148GTL-DX (EARLY) LATE

This is a 'Proven' modification for the Clarifier and alignment for improving the SSB use.. As you probably are aware of, this unit uses a two-part clarifier-but only the COARSE section is unlocked as designed. Because of the detent on the COARSE potentiometer, synchronizing the RX and TX frequencies is usually very difficult.. The following 'mod.', and alignment solves all the problems: D.S.

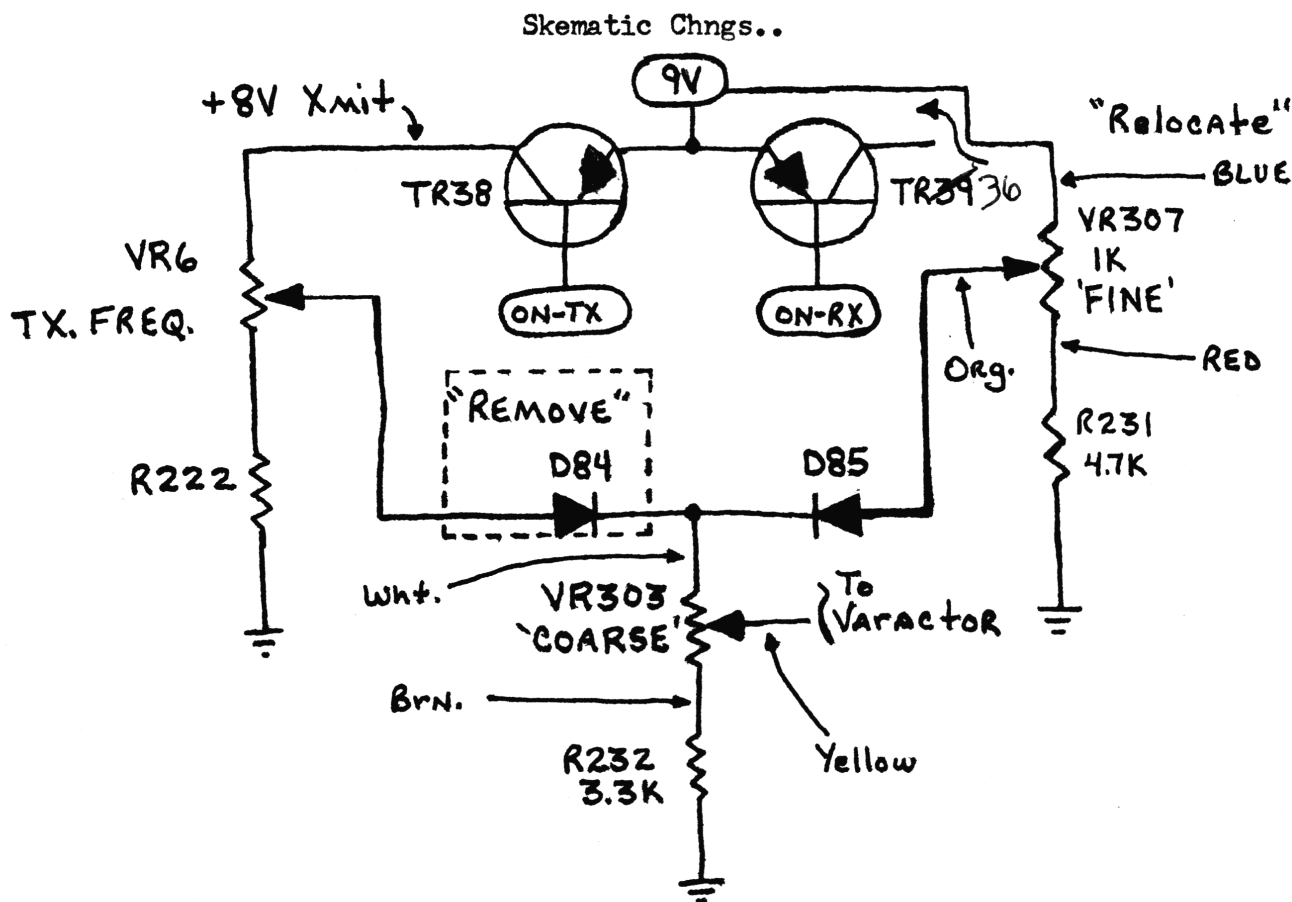
1. Remove D84.
2. Move Blue wire at top end of VR307 (FINE) from TR36 Collector to TR36 Emitter.

3. Realign as follows:

- A. Select CH. 39, MID band.
- B. Monitor TP3 with frequency counter.
- C. Adjust L21 for 16.700000MHz, AM Mode
- D. Adjust L22 for 16.702500MHz, USB Mode
- E. Adjust L23 for 16.697500MHz, LSB Mode
- F. Adjust L17 for maximum RF at TP4 (Rec).
- G. Adjust L19 for maximum RF at TP3 (Rec).
- H. On CH. 40, adjust L18 for 2.5VDC at TP2.
- I. Adjust L52, L53, and L55 for max power output; Xmt on CH. 40, AM.
- J. Adjust VR7 to null carrier on LSB Xmit.
- K. Adjust VR8 for correct output power reading on TX PWR MTR.
- L. Adjust VR13 for 6 watt output power (AM).
- M. Adjust the following in Receive for max S-meter reading:
L7, L8, L9, L11, L12, L13, L14, L15...
- N. With 100 microvolt input adjust the following:
VR2 for S9 reading in AM Mode.
VR1 for S9 reading in SSB Mode.
